Date: April, 2022

**Quick Positioning Brackets - For Aluminum Frames "CUAB"
Tablet PC Holders - Quick Positioning Type - For Aluminum Frames "DTAC-AB"
Notice on Product Discontinuation and Launch of Successor Products**

Quick Positioning Brackets - For Aluminum Frames

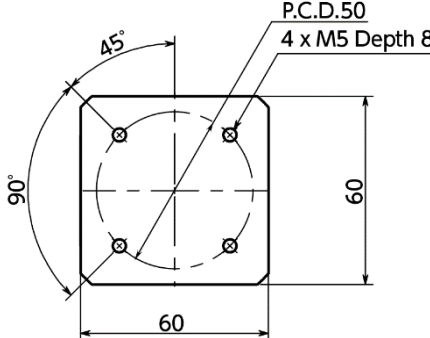
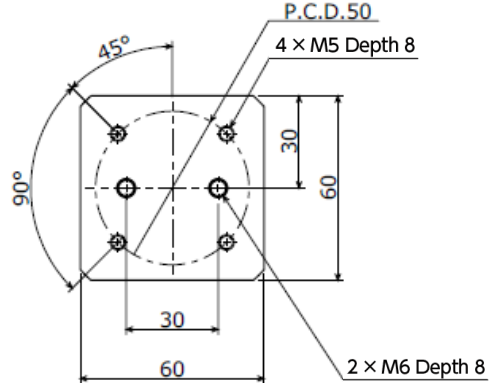
Discontinued Products	Successor (New) Products
CUAB-30	CUAB-30-A
CUAB-40	CUAB-40-A

Quick Positioning Brackets - For Aluminum Frames

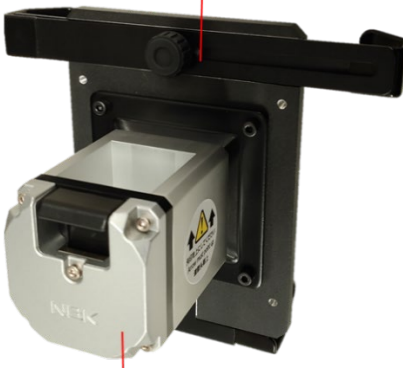
- The cover material has been changed.
- Through changing the resin sheet to a setscrew (polycarbonate), the play when retaining the aluminum frame or square shaft can be reduced through adjusting the setscrew screw-in depth.
- Through adding a workpiece mounting female screw (M6) at the back, a wider range of workpieces can be mounting.
